# Building Code of Australia 2022 Report

PROJECT NAME: Ulladulla Public School Upgrade - 241 Green Street, Ulladulla NSW 2539  
PROJECT NUMBER: **GDL240198**  
DATE: **25/03/2025 (Rev E)**

This BCA Assessment Report has been prepared to support a Review of Environmental Factors (REF) for the NSW Department of Education (DoE) for Ulladulla Public School upgrade (the activity).

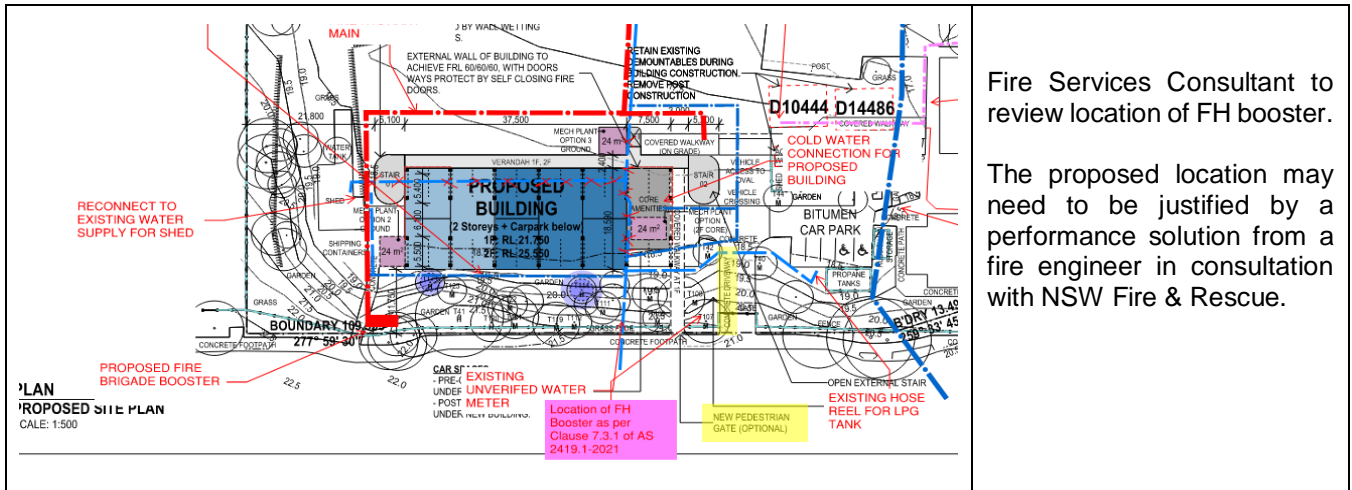
The external stairways (FS01 & FS02) are located adjacent to the eastern and western external walls of the building. The stairway connects and provides egress from level 01 and 02 and discharge at the ground floor within close proximity to openings within the multi-deck carpark. A review of the design has identified the following departures from the DtS provisions:

- The external stairway circulation zone at the landing of Level 01 will be within 6.0m to the external walls. The external walls within 6.0m zone are required to achieve an FRL 60/60/60 with openings protected by wall-wetting drenchers. Compliance will not be achieved with BCA Clause D2D13 (3). There are openings situated within 3.0m which are not permitted under D2D13 (3) (a) (ii).
- The openings to the open-deck carpark are exposed to the external stairway. The bounding construction of the external stairway within 6.0m to the open-deck carpark are required to achieve an FRL 60/60/60 in accordance with Clause D2D13 (3). It is noted that open perforated mesh surrounds the external stairway.

The abovementioned non-compliance with the DtS provisions will require consultation with the fire engineer to establish that a performance solution is feasible at the crown certificate stage.

## Travel Distances Assessment:

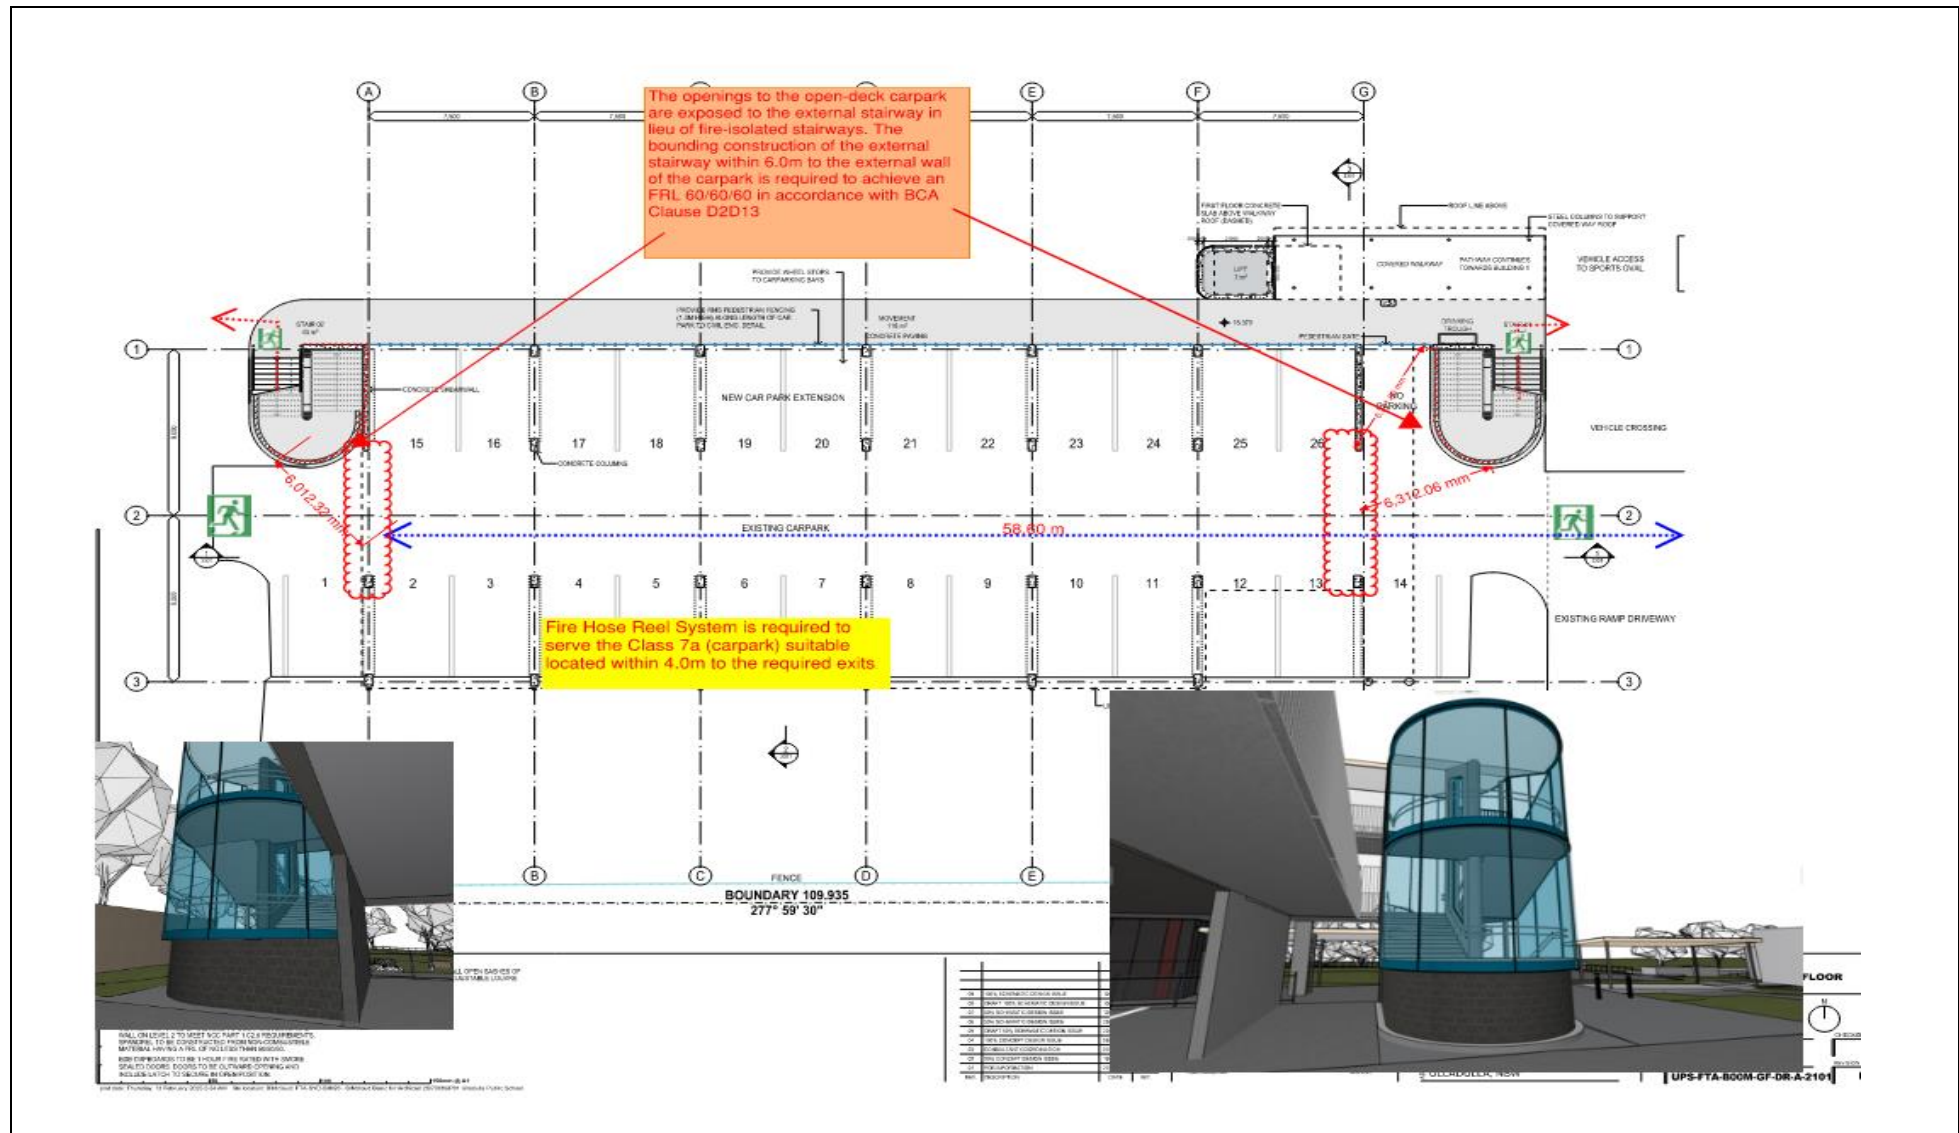
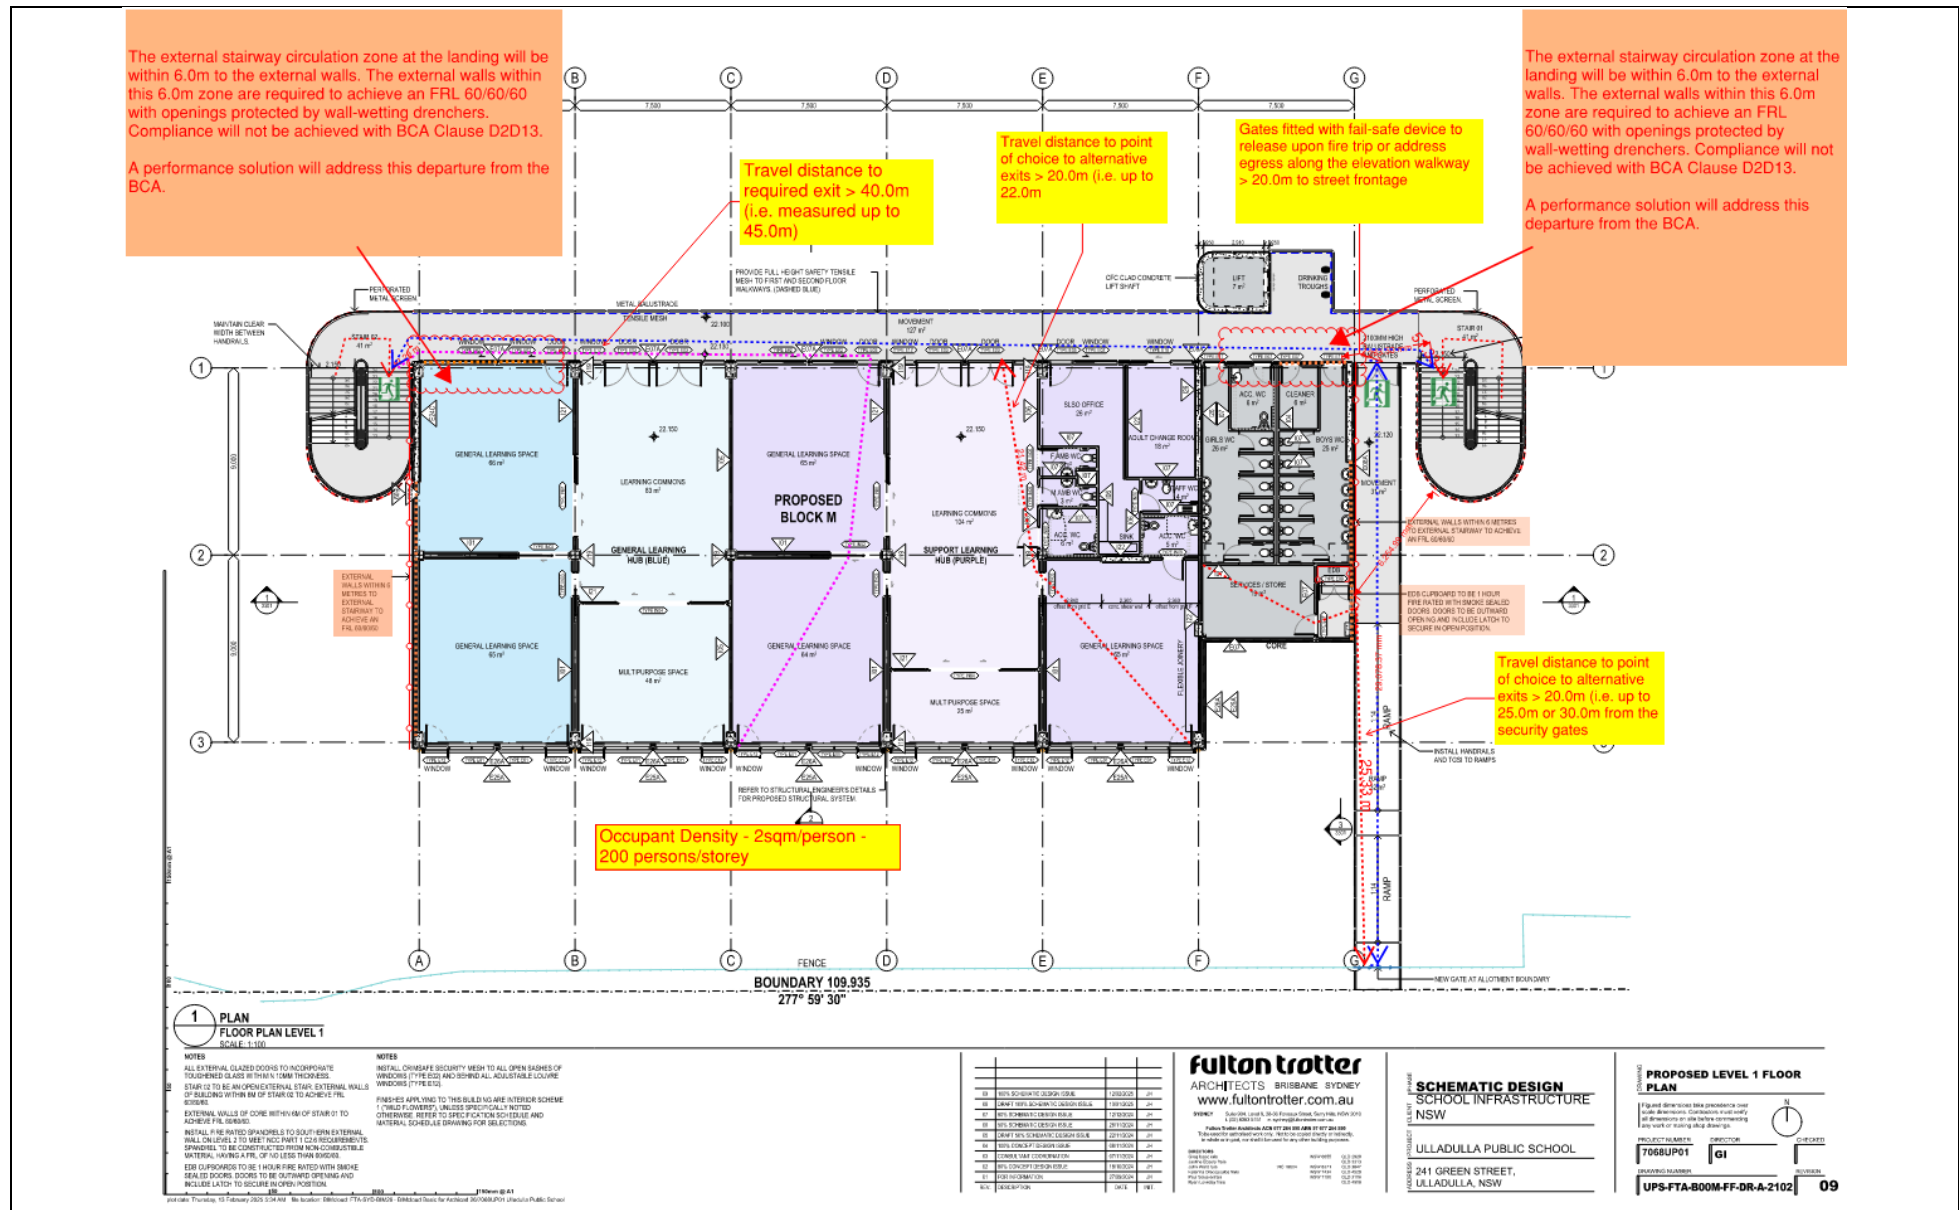
Location	DTS Travel Distance Requirement	Current condition	Performance Requirement	Resolution
Level 2	<ul style="list-style-type: none"> <li>20m max. to a point of choice.</li> <li>40m max. to an exit (where min of Two. provided).</li> <li>60m max between alternative exits</li> <li>9m min.</li> </ul>	20/ <b>45</b> /60	D1P4, E2P2	Travel distance to required exit > 40.0m (i.e. measured up to 45.0m). Compliance will not be achieved with DtS provisions. Performance Solution to be prepared from a fire engineer.
Level 1	<ul style="list-style-type: none"> <li>20m max. to a point of choice.</li> <li>40m max. to an exit (where min of Two. provided)</li> <li>60m max between alternative exits</li> <li>9m min.</li> </ul>	<b>30</b> /45/60	D1P4, E2P2	<ul style="list-style-type: none"> <li>➤ Travel distance from GLS to point of choice to alternative exits &gt; 20.0m (i.e. up to 22.0m).</li> <li>➤ Travel distance to required exit &gt; 40.0m (i.e. measured up to 45.0m).</li> <li>➤ Travel distance from services/Store via elevation walkway to road &gt; 20.0m (i.e. up to 26.0m).</li> <li>➤ Travel distance from security gates to road along the elevated walkway up to 30.0m in lieu of 20.0m.</li> </ul> Performance Solution to be prepared from a fire engineer.

Carpark	<ul style="list-style-type: none"> <li>20m max. to a point of choice.</li> <li>40m max. to an exit (where min of Two. provided)</li> <li>60m max between alternative exits</li> <li>9m min.</li> </ul>	20/40/60	N/A	Travel distance within the open-deck carpark will comply with the DtS provisions of the BCA. The required exit has been assessed at gridline A & G.
